DEVELOPMENT APPLICATION ASSESSMENT REPORT

Application Number:	DA2021/2260
----------------------------	-------------

Responsible Officer:	Megan Surtees
Land to be developed (Address):	Lot 27 DP 6544, 11 Oak Street NORTH NARRABEEN NSW 2101
Proposed Development:	Demolition works and construction of a dwelling house including a swimming pool
Zoning:	R2 Low Density Residential
Development Permissible:	Yes
Existing Use Rights:	Yes
Consent Authority:	Northern Beaches Council
Land and Environment Court Action:	No
Owner:	Axil Raymond Pavy
Applicant:	Planning Approvals

Image 1. Southern elevation envelope breach indicated at the rear of the dwelling (yellow).

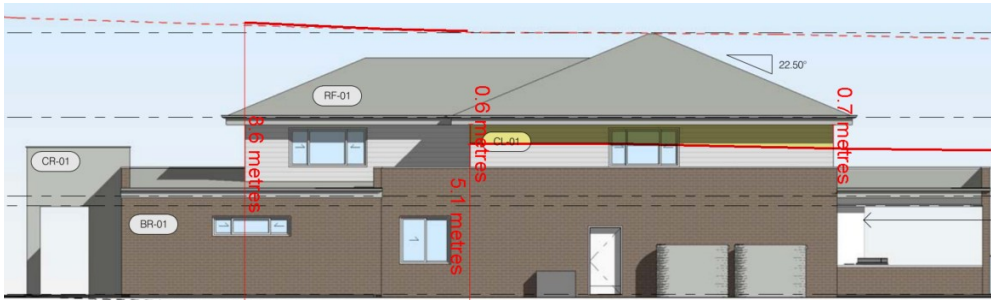
The proposed development results in a minor encroachment between 0.6m and 0.7m for a distance of

11.2m along the southern elevation (see Image 1., below). A merit assessment of the proposed development against the controls requirements is conducted below.

The proposed development includes the construction of a dwelling house that is no more than two (2) storeys, which is commensurate with dwellings within the immediate vicinity. Additionally, the proposed landscaping works will provide visual relief of the built form, and positively contribute to the landscape setting of the locality. As such, the proposed development is consistent with the desired future character of the North Narrabeen locality.

As discussed elsewhere in this report, the proposed dwelling is generally compliant with the built form controls (side and front setbacks), with a maximum height that is no more than 2 storeys. The non-compliant building envelope is minor and does not give rise to any unreasonable environmental or amenity impacts. Additionally, the proposal also includes substantial replacement planting which will provide visual relief of the built form. As such, Council can be satisfied that the bulk and scale of the
